Barangaroo - Headland Park - Main Works MP10_0048 – Major Project Submission

Submission to the Department of Planning 24 December 2010

24 December 2010

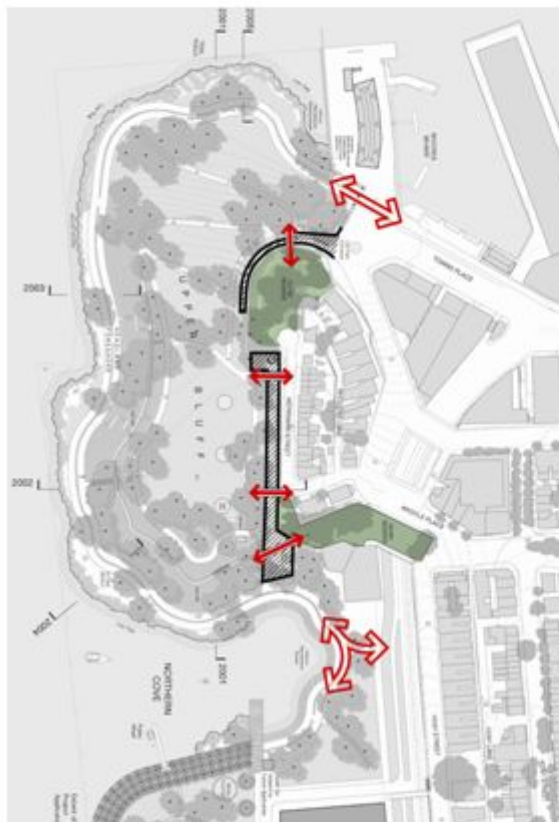
This approach of physically separating the new park land from the existing headland has resulted in access points being provided as a series of narrow entry points (rather than open boundaries such as at The Domain). Two primary access points are proposed (designed as gateways) at Towns Place and The Hungry Mile. Four secondary access points are proposed at Clyne Reserve, Merriman Street and Munn Reserve. These are designed as 2-3m wide bridges over the 10m wide car-park entry cutting and void. The remainder of the Headland Park frontage is separated from Millers Point by fences and low walls along deep cuttings along the line of the existing cliff-face, as shown in the applicant's visual analysis. No details or documentation is provided regarding the design,

height or materials of these boundary fences/walls, and the treatment of the void space is also unclear as to whether it is open or glazed and for what extent.

- The landscape design and public domain plans should be amended to indicate how the proposal can relate to public domain areas adjacent to the Headland Park site boundary, particularly Argyle Street, Clyne and Munn Reserves;

- The park access from Clyne and Munn Reserves should be widened to provide 'land bridge' treatments extending the width of the frontage to the public reserves with a seamless transition from the reserves to the new Headland Park;

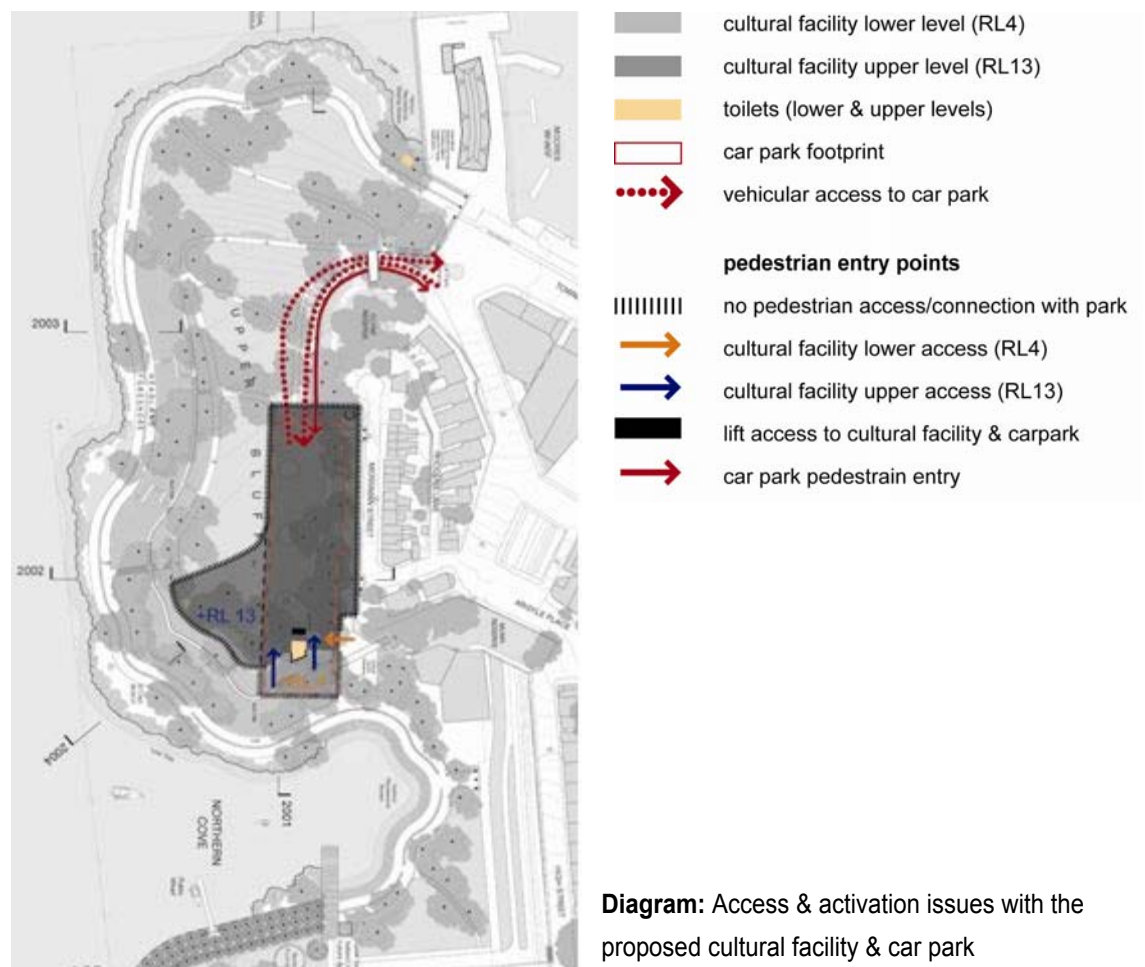
As proposed, the space under the headland is designed as an internalised shell with only two entry points at the southern end of the park (at RL4 and RL13). Similarly, the car park under the headland is provided with a main pedestrian access point via the cultural facility at the southern end of the park, with a secondary access path along the driveway ramp in the north.

It is not clear how such a space would be fully serviced and what impacts future servicing might have on the park itself.

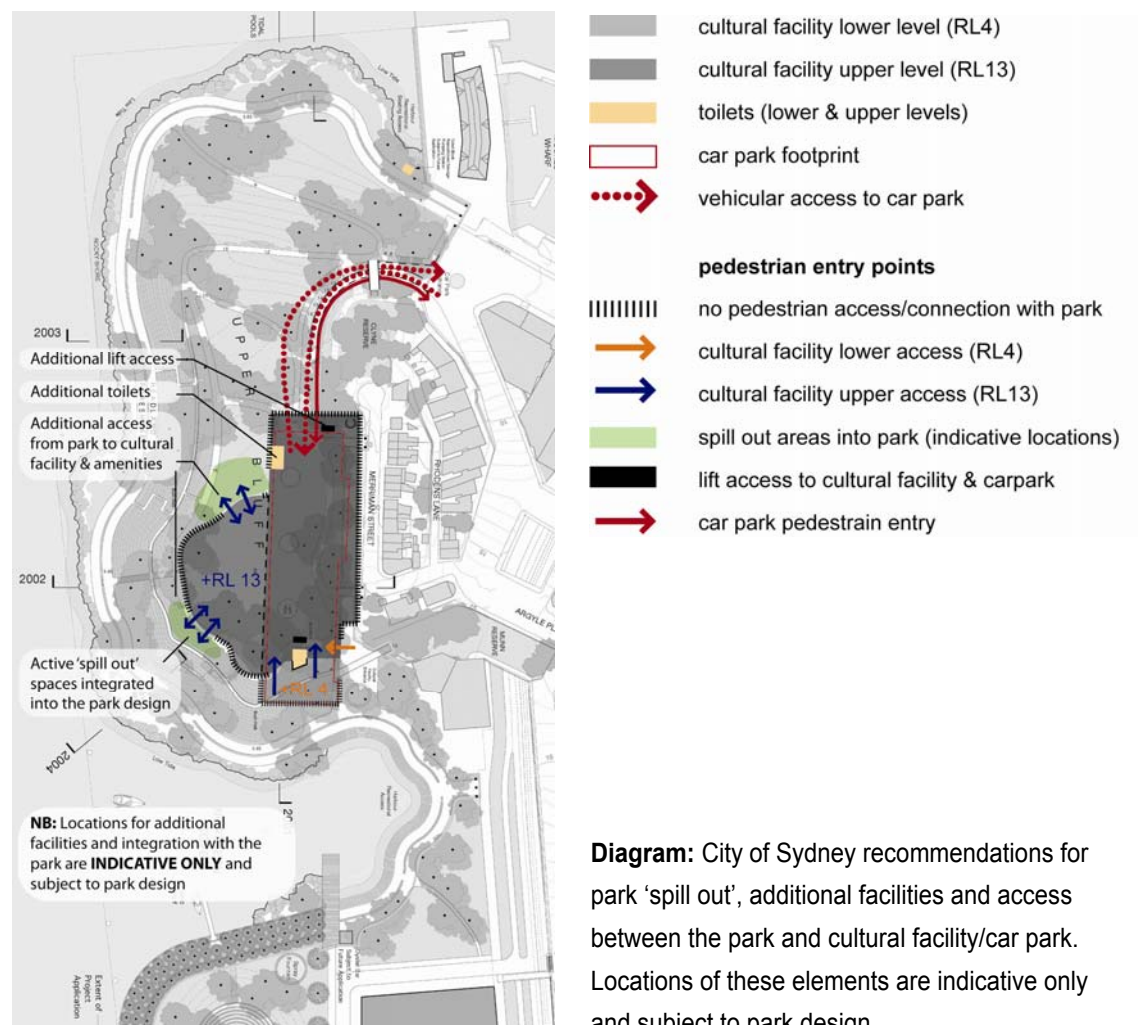
Other than the relocated sewer pumping station (to be reused as toilets) there are no amenities provided in the Headland Park. The shell under the park provides an opportunity

to integrate the provision of important park amenities such as toilets, kiosks, cafes and shelter, whilst preserving the parkland design intent of a naturalized headland.
